**SCHWEIZER
SERVICE INFORMATION
LETTER**

LETTER NO. L-107
DATE 10 December 1979
PAGE 1 OF 2

SUBJECT: NEW COMFORT CLIPS FOR SAM BROWNE SEAT BELT AND
SHOULDER HARNESS ASSEMBLIES

MODELS AFFECTED: Model 269C Helicopters equipped with PN 269A4345
Sam Browne seat belt assemblies, Serial No. 0530
thru 0960

Figure 1. Comfort Clip Decal Application
 And Clip Installation Instructions

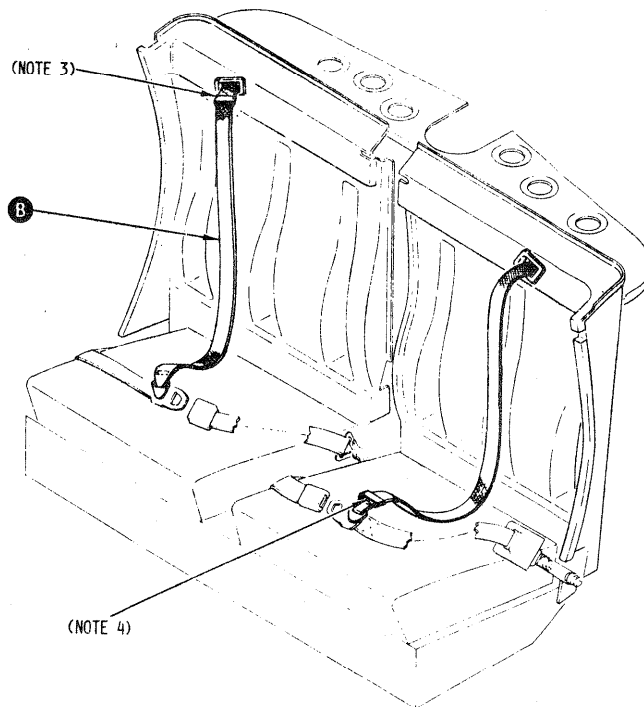
A new comfort clip (PN E3403) designed to maintain proper strap tension, and relieve excessive pressure of the inertia reel shoulder harness on the pilot or passenger during flight, is now available for the above affected helicopters equipped with Sam Browne seat belt assemblies.

After each seat belt and shoulder harness assembly is fastened and adjusted for individual comfort and safety, the comfort clip is moved from its original position next to the buckle and relocated by sliding up on the harness strap as close as possible to the inertia reel (see Figure 1). The clip prevents any further retraction of the strap into the inertia reel, thus keeping a constant yet comfortable tension of the harness strap against the pilot or passenger. After each flight, the comfort clip is to be returned to its original location on the harness strap next to the buckle.

1. CLEAN DOOR FRAME AREA WHERE DECALS ARE TO BE APPLIED. DECALS WILL NOT ADHERE TO A GREASY OR SOAPY FILM.
2. MARK LOCATION OF DECAL PER THE ILLUSTRATION. REPEAT ON THE OTHER DOOR FRAME.
3. PEEL BACKING OFF DECAL AND POSITION. USE A CLOTH TO SQUEEZE ALL BUBBLES FROM UNDER THE DECAL, WORKING FROM THE CENTER OUTWARD. REPEAT ON THE OTHER DOOR FRAME.

1. PRY OPEN SLOT ON UNDERSIDE OF CLIP.
2. INSERT HARNESS STRAP IN SLOT.

3. SLIDE COMFORT CLIP UP ON HARNESS STRAP AND POSITION AS CLOSE AS POSSIBLE NEXT TO INERTIA REEL.

4. REPOSITION COMFORT CLIP ON HARNESS STRAP AT ORIGINAL POSITION NEXT TO BUCKLE.
